Case No. 2023-00246
Dogwood Corners LLC
Response to Staff's First Request for Information

STAFF DR 1-1:

STAFF DR 1-18:

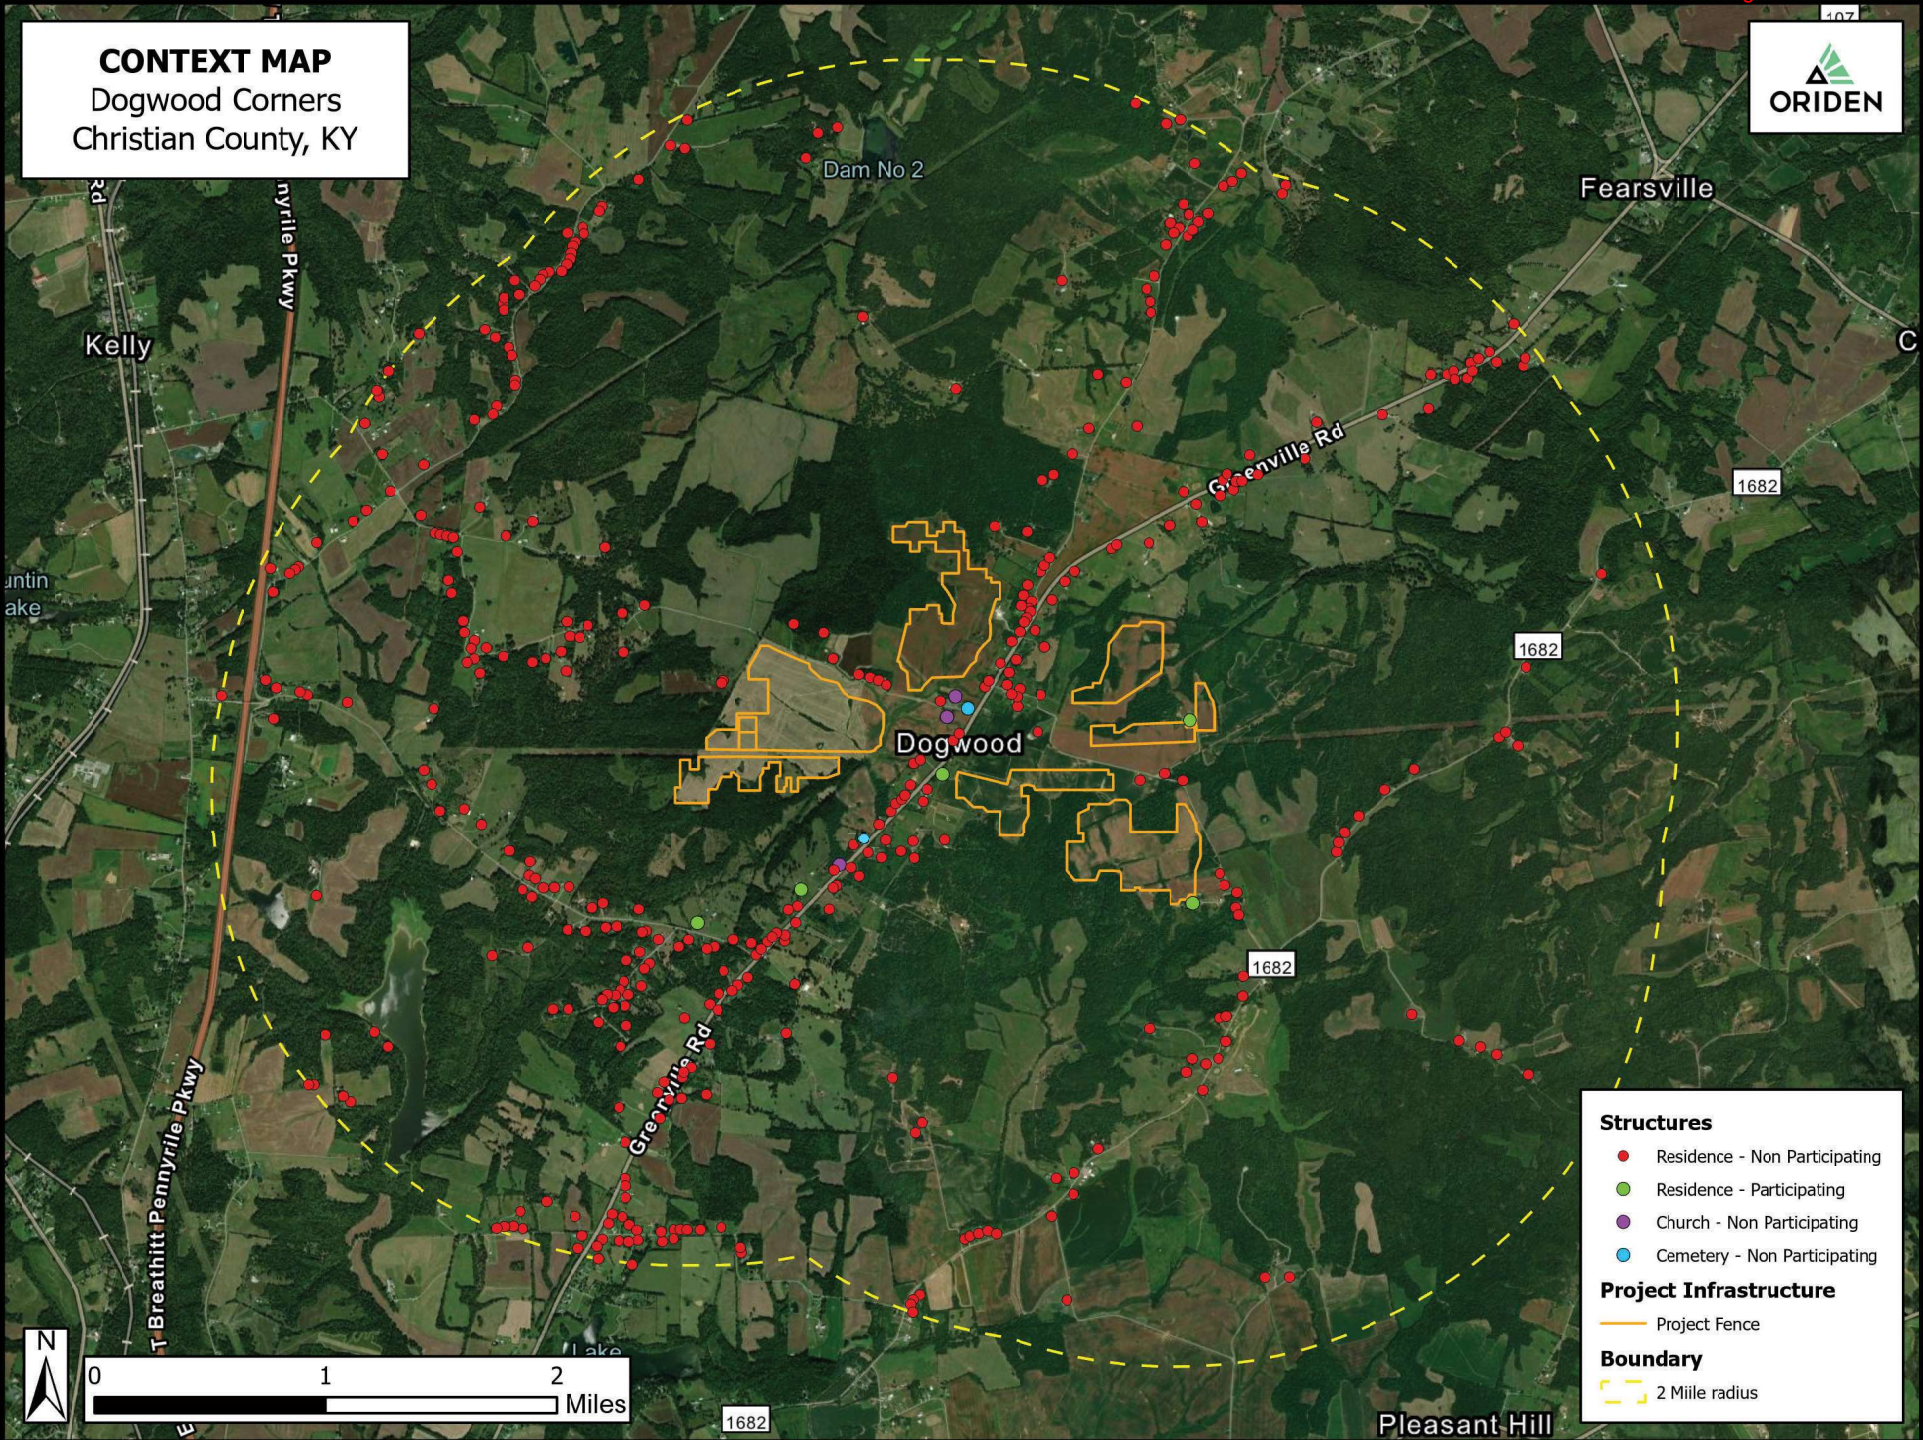
Refer to the Application, Attachment A, Context Map. Provided an updated context map that contains any community structures including churches, cemeteries, or community centers.

Response: Please refer to the attached Context Map.

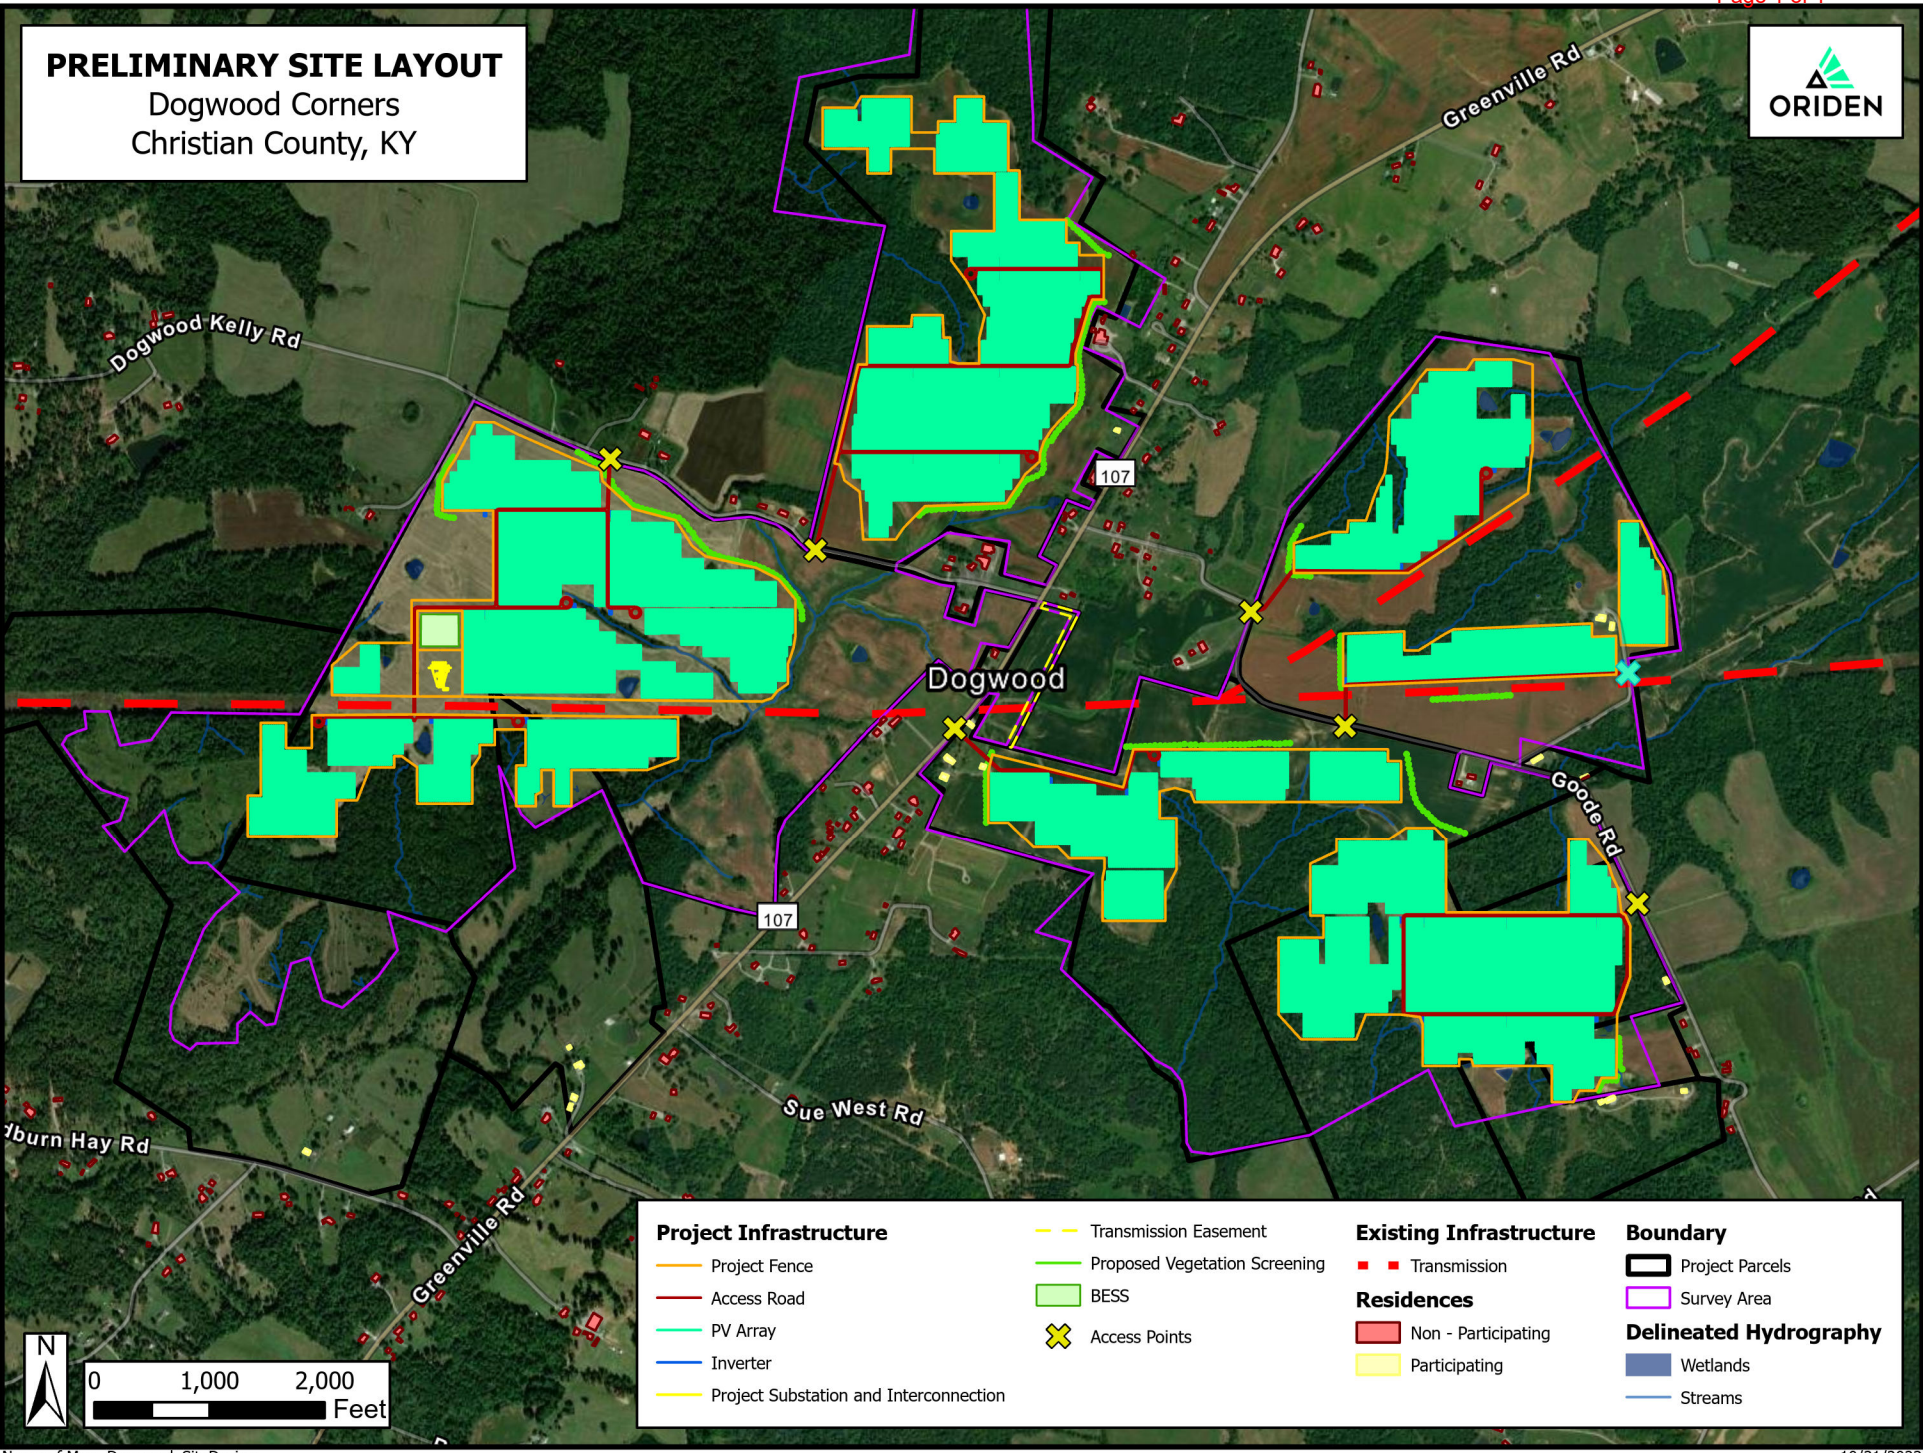
Refer to the Application, Section 2, Site Assessment Report (SAR), Appendix B, Preliminary Site Layout. Provided an updated site layout that contains:

- a. Parcel boundaries.
- b. Perimeter fences.
- c. Access roads.
- d. Access points.
- e. Transmission line.
- f. Substation and interconnection.
- g. Battery energy storage system (BESS).
- h. Vegetative screening.

Response: Please refer to the attached, updated Preliminary Site Layout. Dogwood Corners anticipates that it will need to change the location of the substation and interconnection, and is working to finalize that location. When the location is finalized, Dogwood Corners will supplement this response with another updated Site Layout Plan.

STAFF DR 1-22:

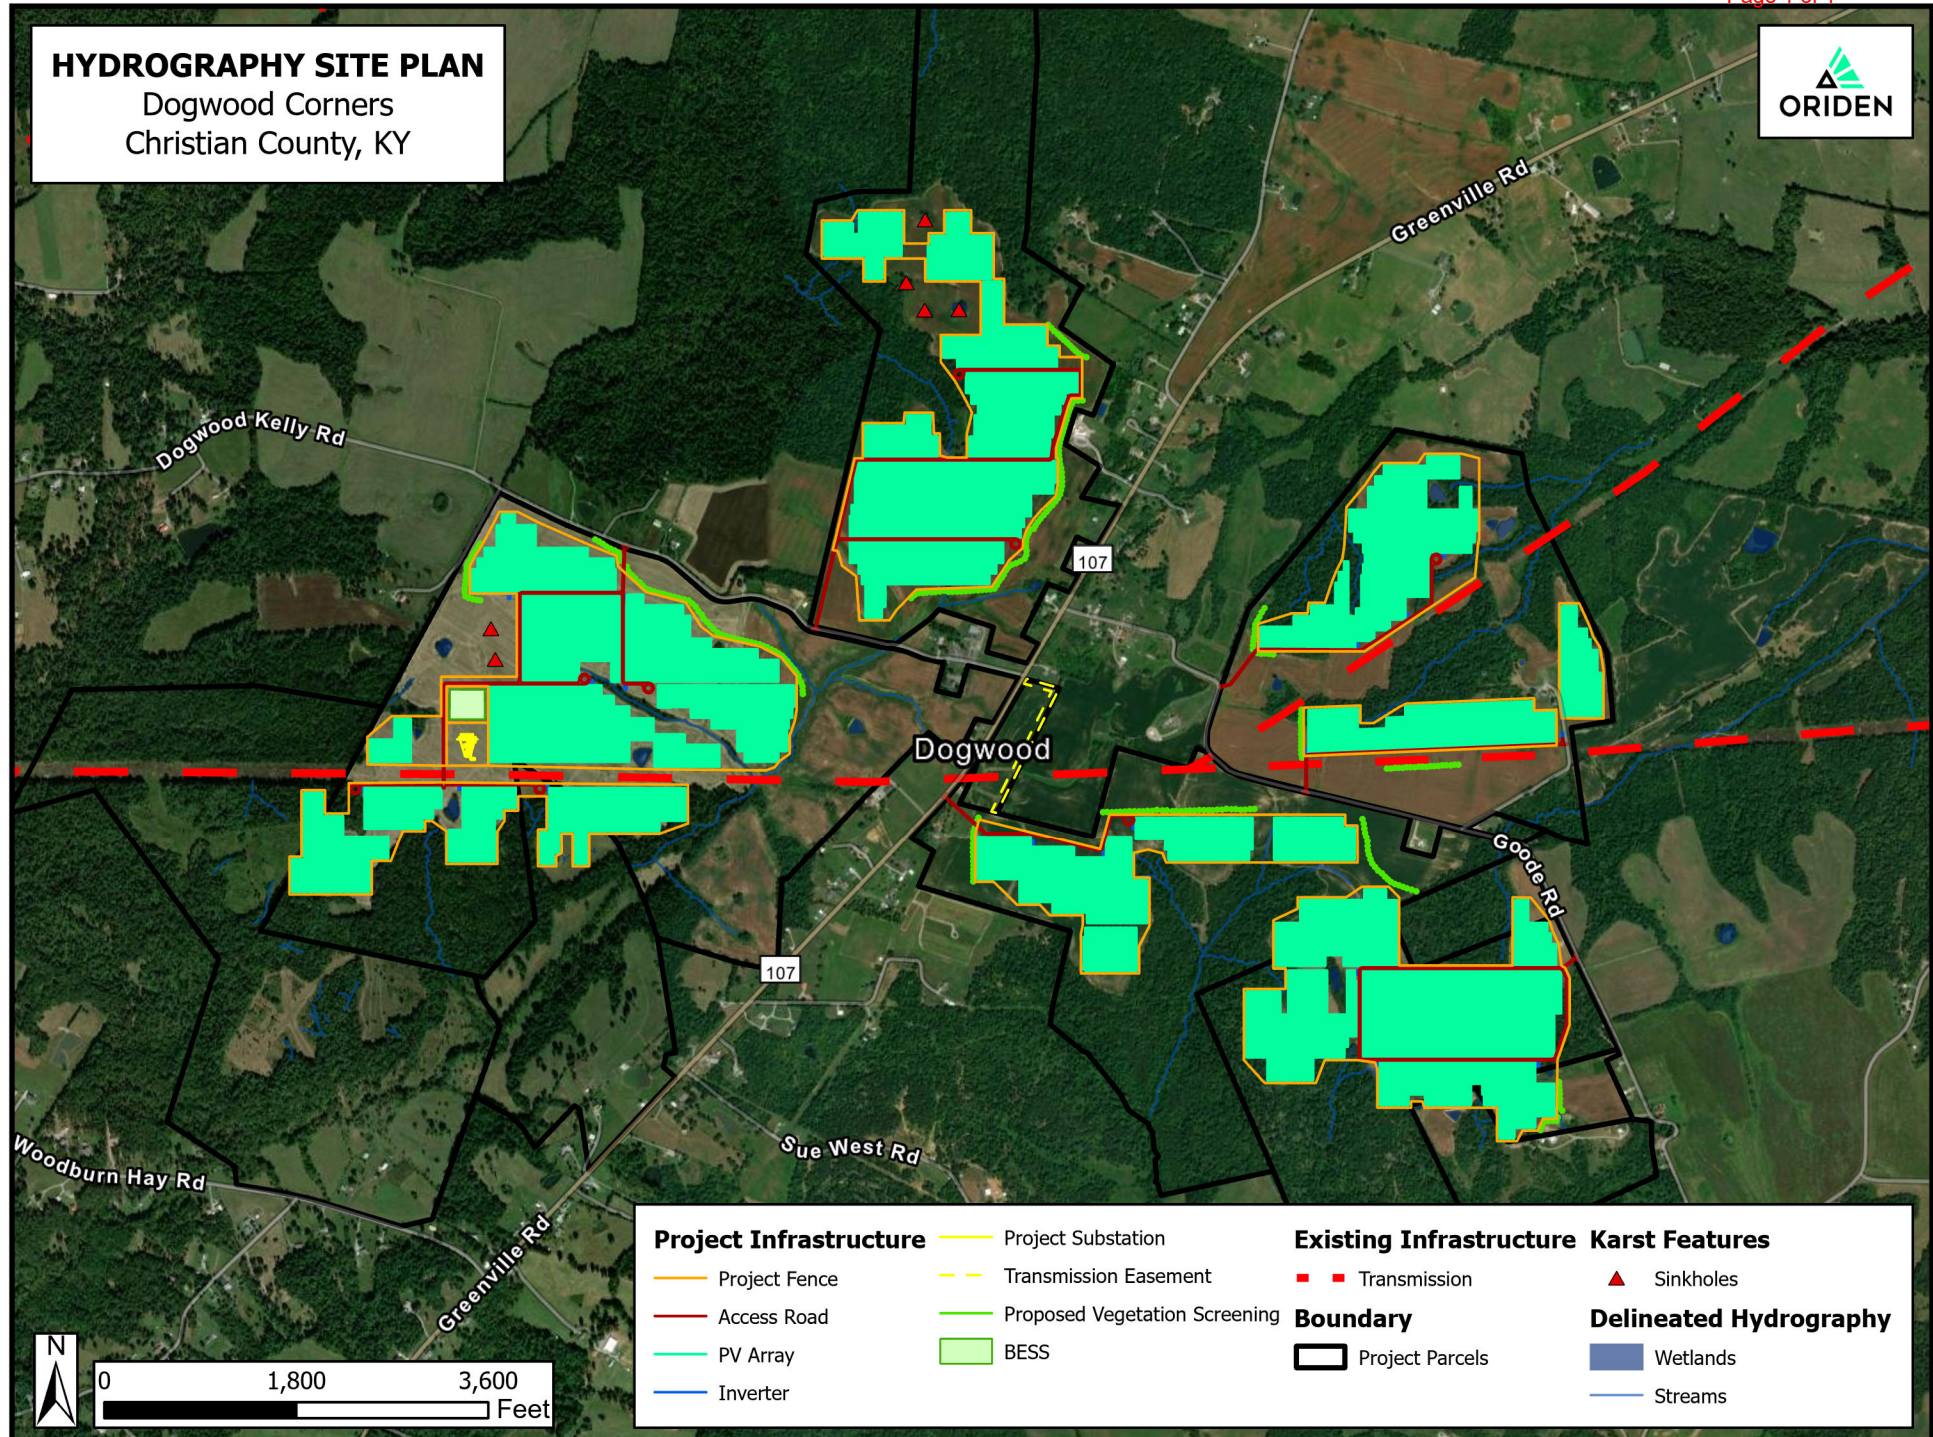
Refer to the SAR, Appendix B, Preliminary Site Layout. Provide a one-page site map that contains the locations water features, including rivers, streams, lakes, and ponds. Also include any known or suspected karst features, including sinkholes and drainage areas.

STAFF DR 1-29:

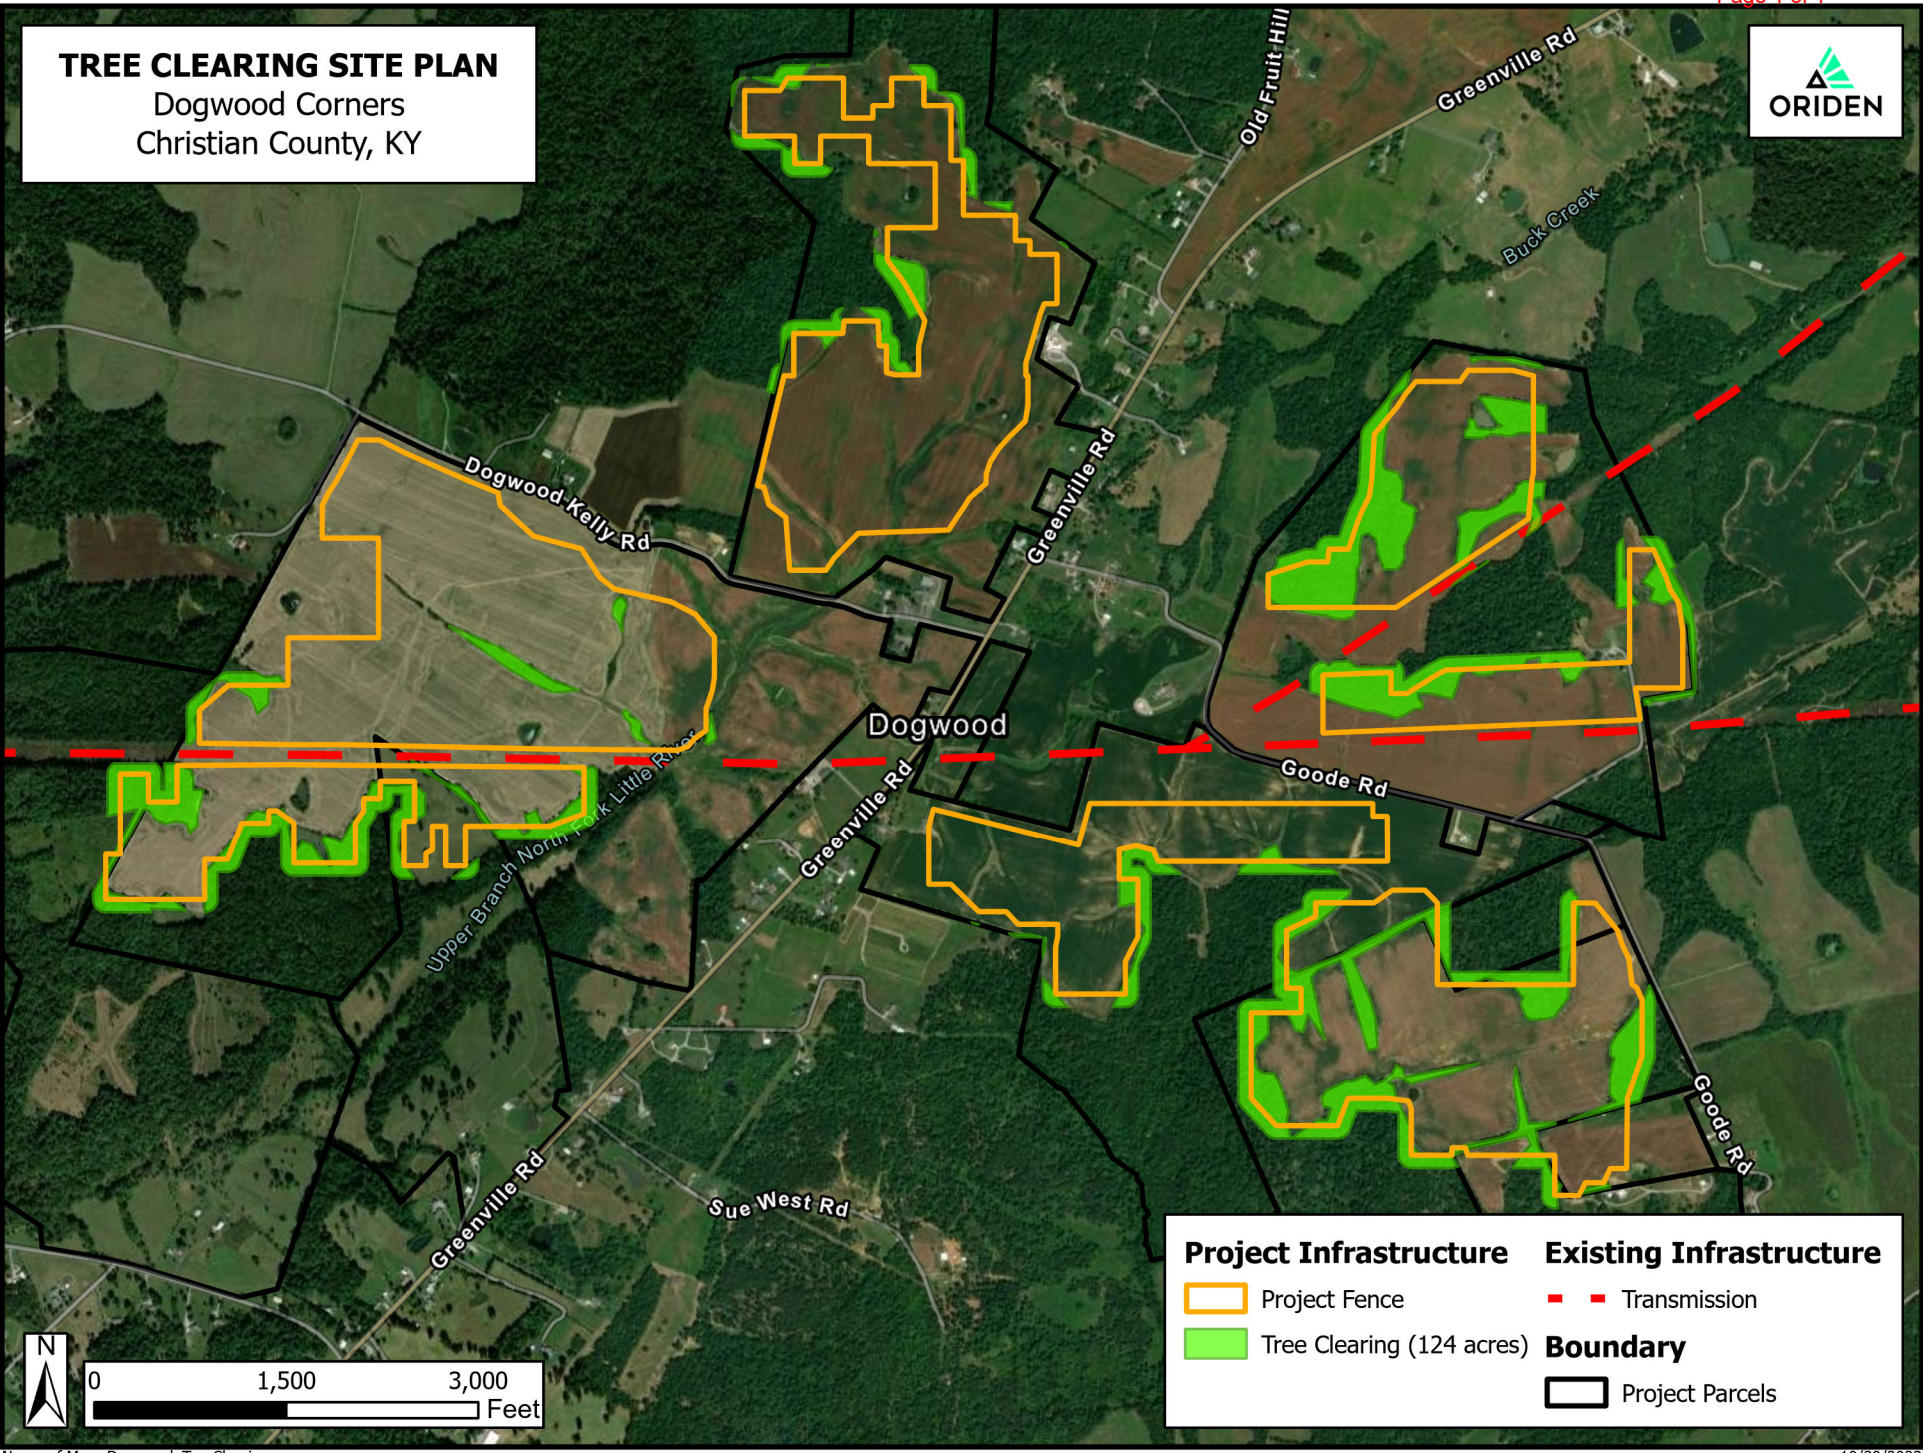
Refer to the SAR, Appendix B, Preliminary Site Layout. Explain whether there will be vegetation clearing for construction. Provide in the response the number of acres that will be cleared and any permits that will be required.
